Tacoma Public Utilities – Water Division  
3628 South 35<sup>th</sup> Street  
Tacoma, WA 98409-3192  
Contact: Chris R. McMeen

RE: Long-Term 2 Enhanced Surface Water Treatment Rule, Proposed Rule, 68 Federal Register 47639, Docket No. OW-2002-0039

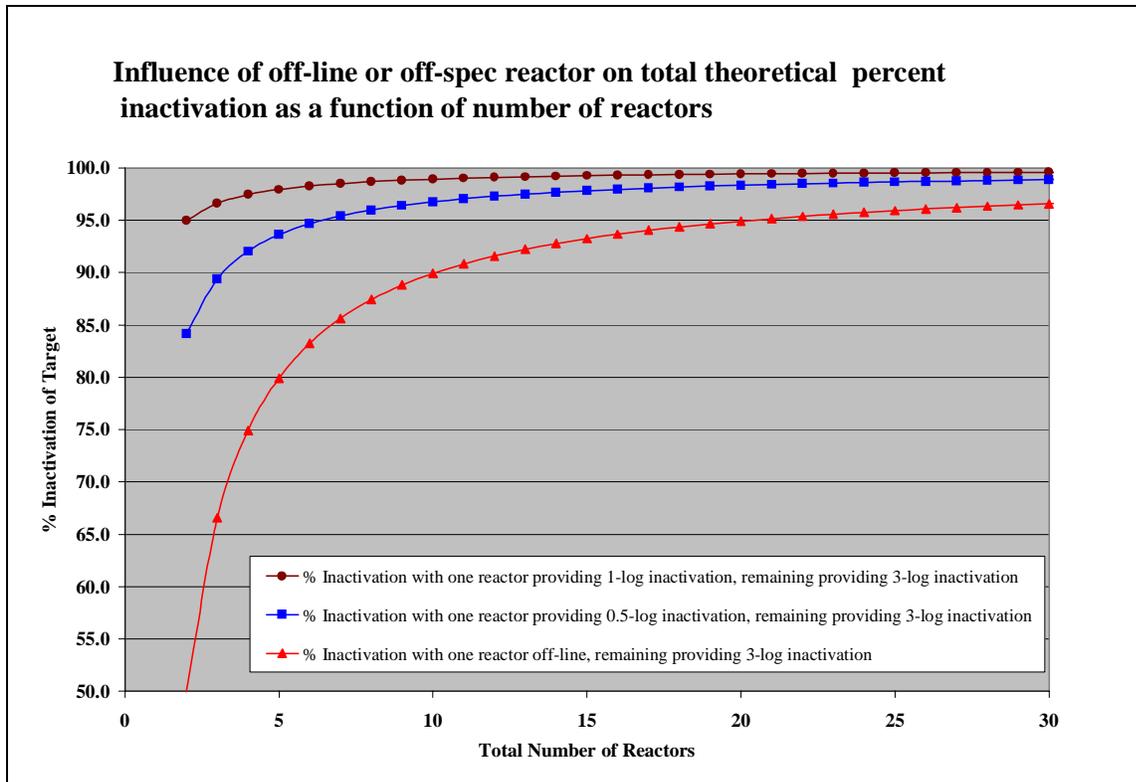
An alternative proposal has been offered for unfiltered system compliance: In that proposal, all reactors in a system must operate within their specified limits at least 95% of the time the system treats water, irrespective of flow or whether the entire system (i.e. all reactors), a single reactor, or a single lamp out causes the out-of-spec performance. We do not agree with this approach. Depending on the number of reactors employed, even if a single reactor is completely out of service, substantial treatment may remain. The following figure illustrates this point.

This chart illustrates, particularly with the number of reactors the vast majority of systems will operate (<10), that there is a tremendous difference in delivered treatment between a reactor that is completely off-line (but passing water) and one that may be out of specification, and the time-based compliance approach is blind to this difference.

We continue to believe that the flow based approach as proposed is appropriate, and can be readily monitored by the utility and regulatory agencies. EPA should evaluate options for differentiating off-line reactors from off-spec reactors.
